Quality Control Check Report. Stage: After Plumbing & Electrical (Apartments)

GULMOHAR RESIDENCY

Details of Additions & Alterations

Flat No	403	Block no.	' D '
Flat Area	1660 sft	Type	Deluxe / Luxury
Buyer Name	P. N. S. Raghav Narayana & P. Serrani		
Phone No.	9908849000	Email	raghu81@gmail.com

Description	Owners & Developers :	Date :	04.09.20	Promoted by
	Modi Reality Mallapur LLP	Prepared By :	Jayapradha	Modi Properties Pvt Ltd
	Project Name & Phase :	Approved By :	Soham Modi	
	Gulmohar Residency	Scale :	N.T.S	Phone: +91-40-66335551
	PLUMBING PLAN-1660 Sft (B2-TYPE)

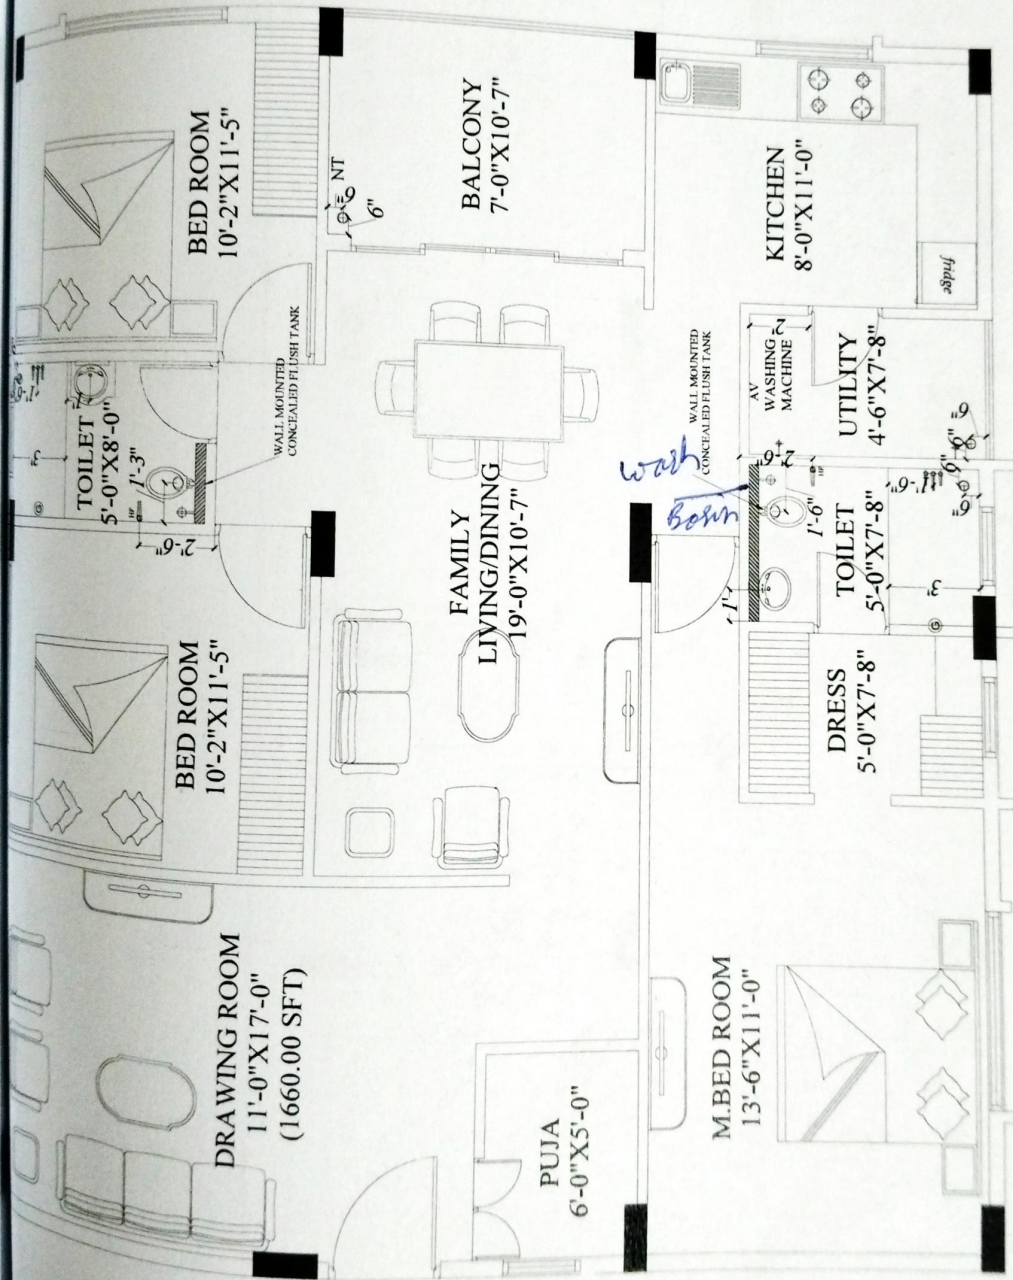
Changes in flooring:

- 1) Hall & Dining: - Crema marble
- 2) 3 Bedrooms: - Urban wood Natural
- 3) Utility floor: - Country Porro
- 4) Kitchen floor by customer tiles.
- 5) Master toilet: - Malayism Brown
- 6) Common toilet: - Lura series

ELECTRICAL PLAN -B2 TYPE-1660 sft

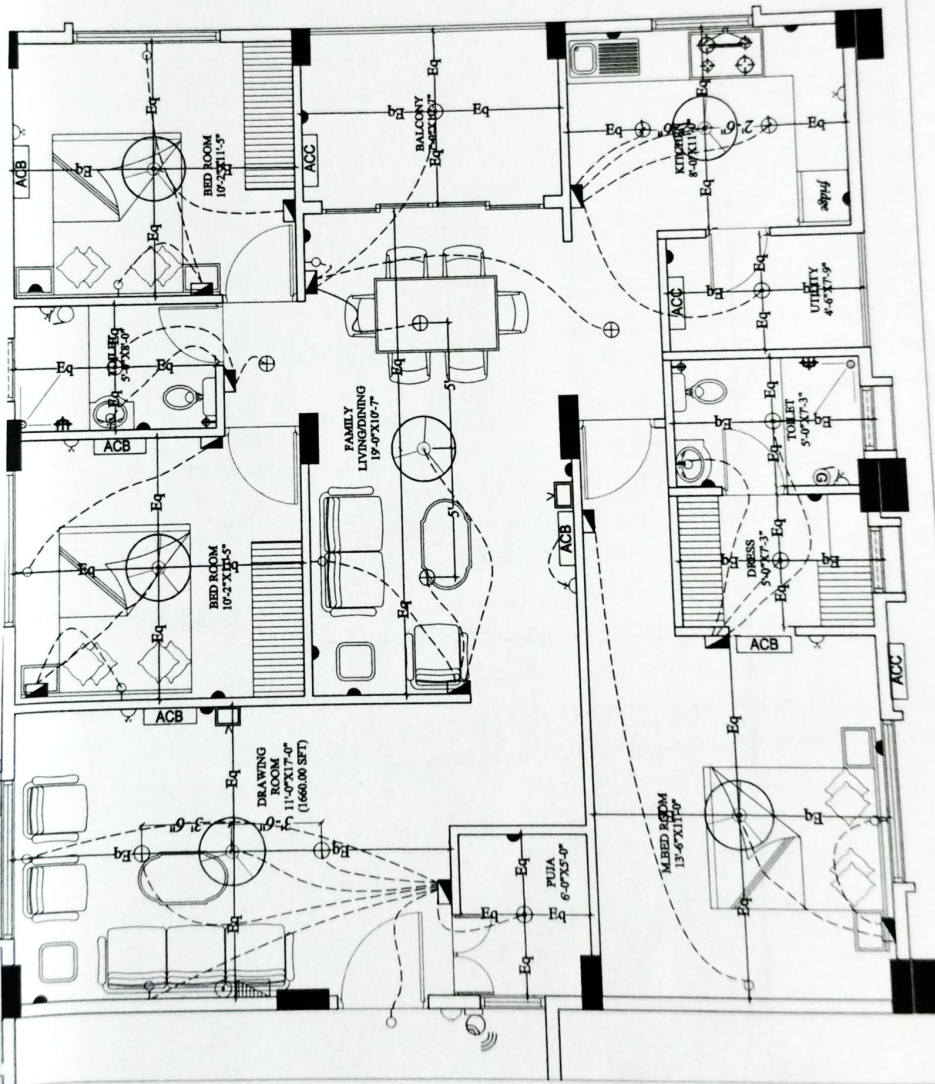
Remarks 1) As per customer's request electrical points were changed. 2) Grey's point (plumbing) is not as per specifications, wash basin inlet pipe not provided in M-6.

Changes in electrical points: (mark on plan)
